FINAL PLAT
IDLE BANKS ADDITION
 SEDGWICK COUNTY, KANSAS
 2002

RE: SUB 2001-84 -- Final Plat of Idle Banks Addition

CASE NUMBER: SUB 2001-84 -- IDLE BANKS ADDITION

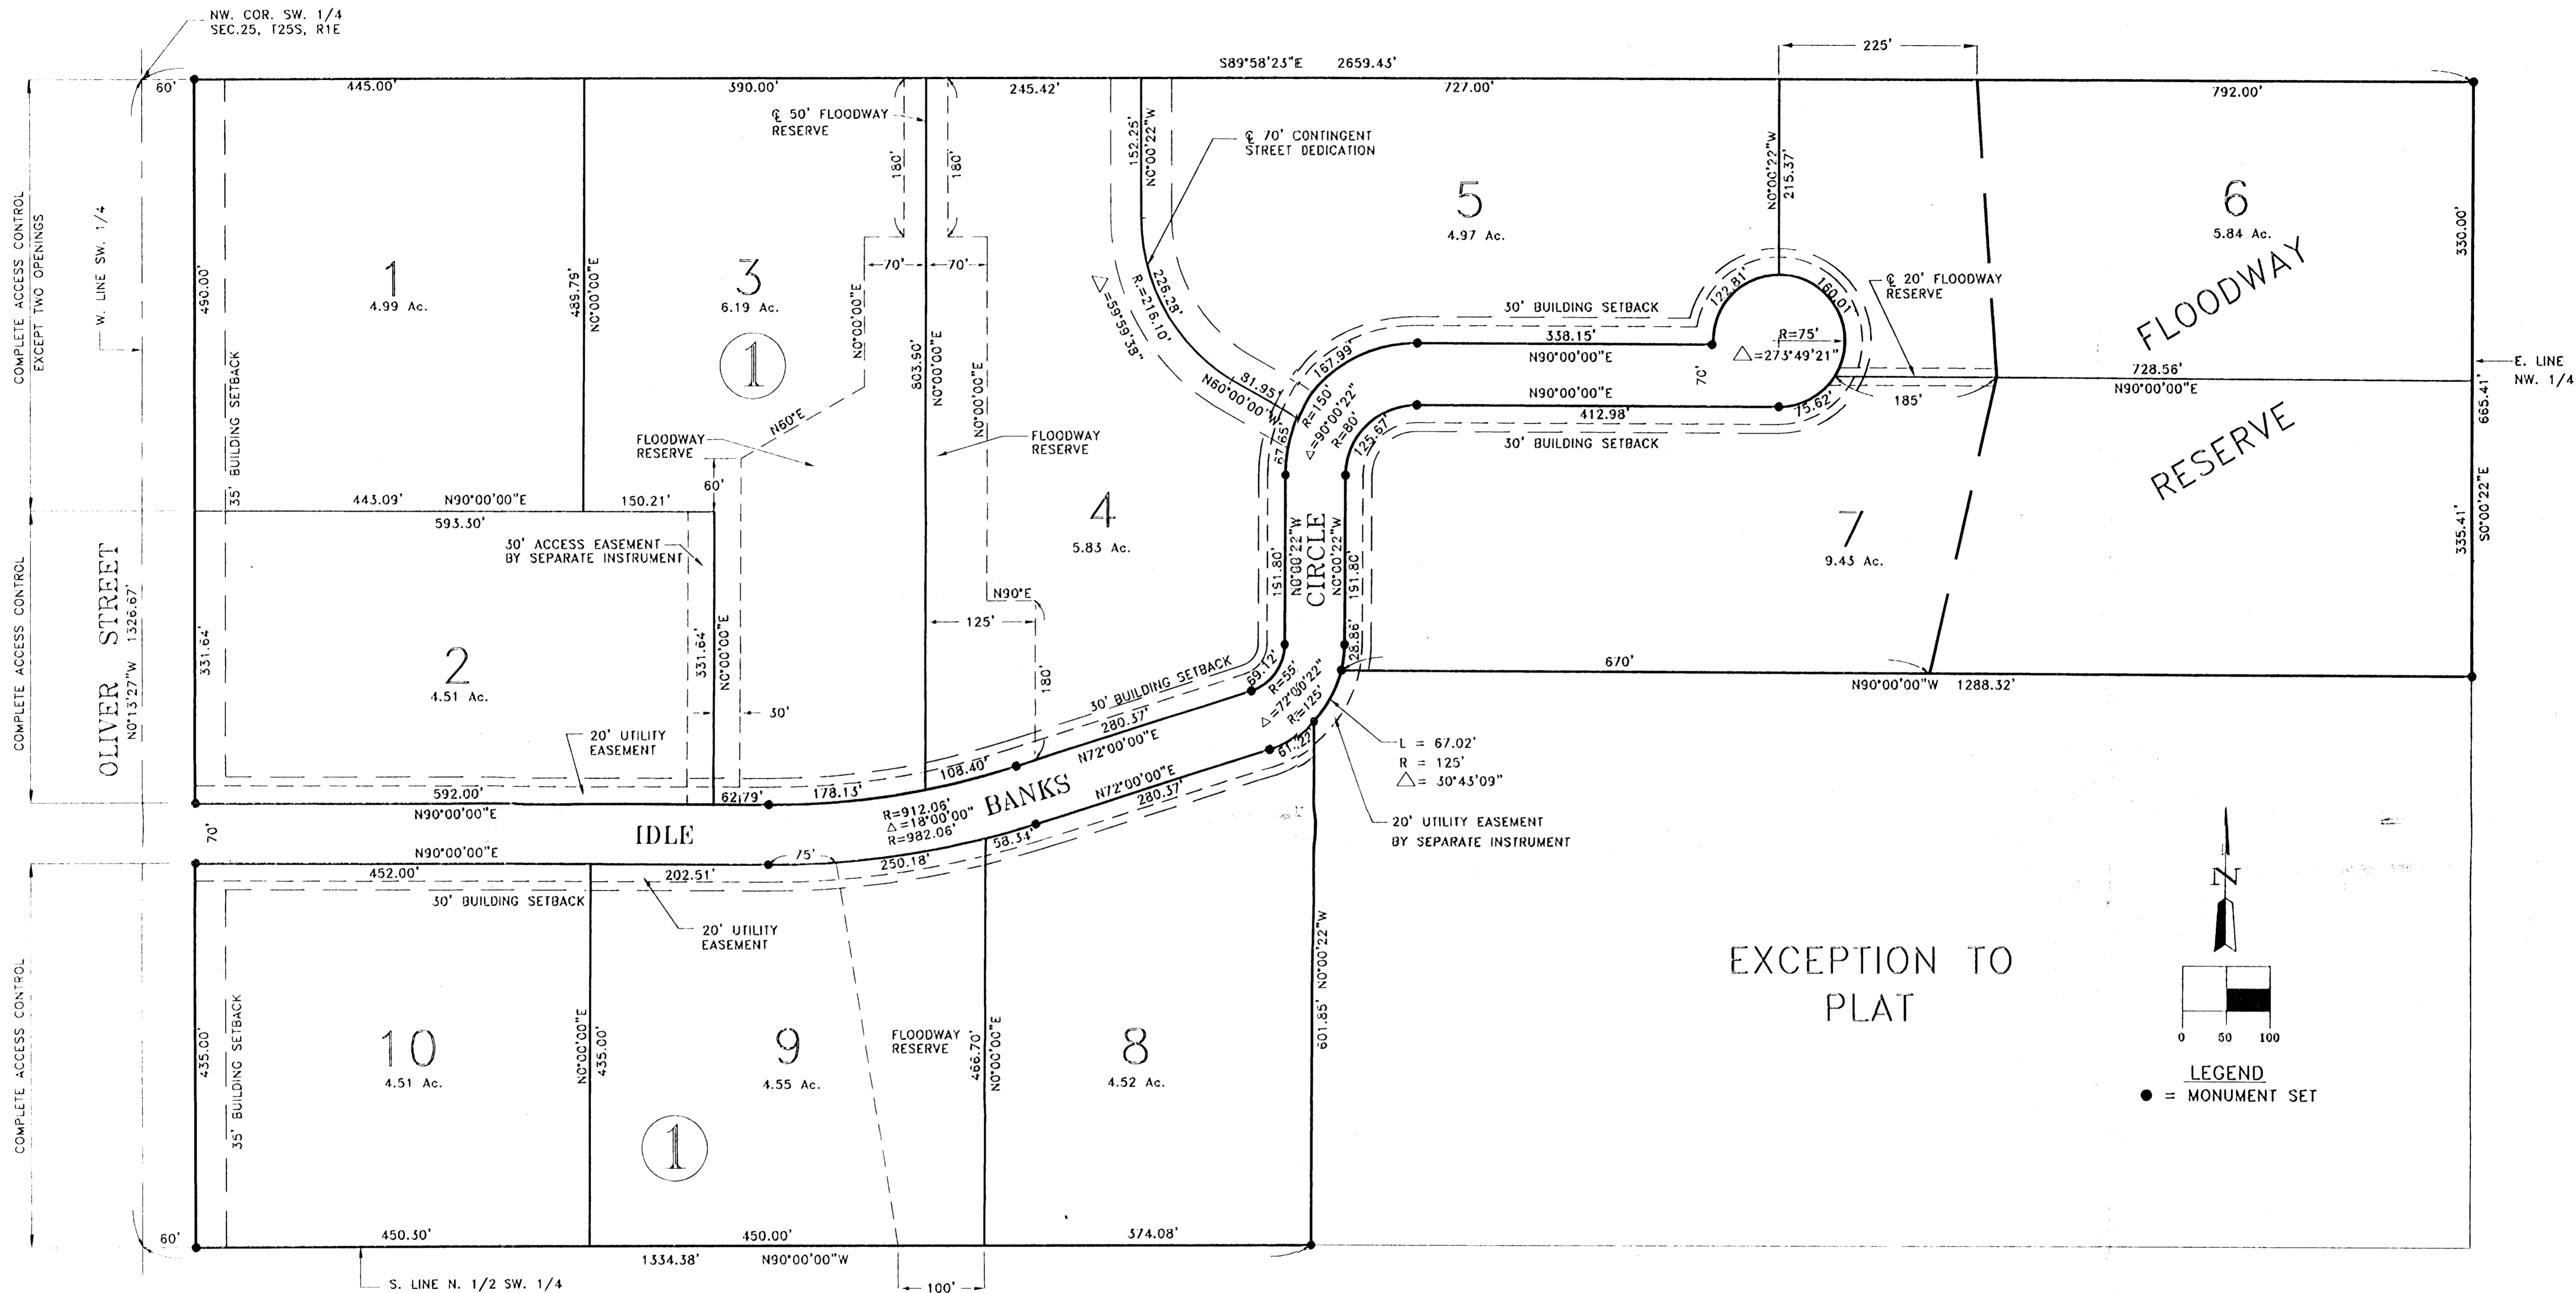
- A. Since neither municipal water nor sanitary sewer is available to serve this property, the applicant shall contact the Environmental Health Division of the **Health Department** to find out what tests may be necessary and what standards are to be met for approval of on-site sewerage facilities and water wells. A memorandum shall be obtained specifying approval. **A layout denoting additional floodway reserve is needed for Lot 6 to determine buildable area. Soil testing is required.**

- D. **County Engineering** needs to comment on the status of the applicant's drainage plan. **County Engineering has advised that a HEC-2 computer run is required across Lots 6 and 7, and additional floodway reserve will be needed on Lot 6 as determined by the computer run. Minimum pads will need to be determined by the computer run. The drainage easements between Lots 3 & 4, between Lots 6 and 7, and between Lots 8 & 9, Block 1, need to be changed to Floodway reserves. A Master Lot grading plan is needed.**

- E. **County Engineering** needs to comment on the access controls. The plat proposes two access openings along Oliver for Lot 1. **The access controls are approved.**

- H. The Applicant is advised that in regard to the structure on Lot 1 within the required 35-ft building setback, that while such areas of the existing structure may be retained, no enlargement of the building in such area will be permitted and if removed, all subsequent rebuilding shall observe building setbacks.

- I. Approval of this plat will require a waiver of the lot depth to width ratio of the Subdivision Regulations for Lot 3 and Lot 6. The Subdivision Regulations state that the maximum depth of all residential lots shall not exceed 2.5 times the width. **A modification has been approved by the Subdivision Committee.**

- M. **County Surveying** has advised that the legal description needs to be corrected. "Section 25 South" needs to be revised to "Section 25, Township 25 South". The curve needs to be noted on the right or southeast side of the chord.
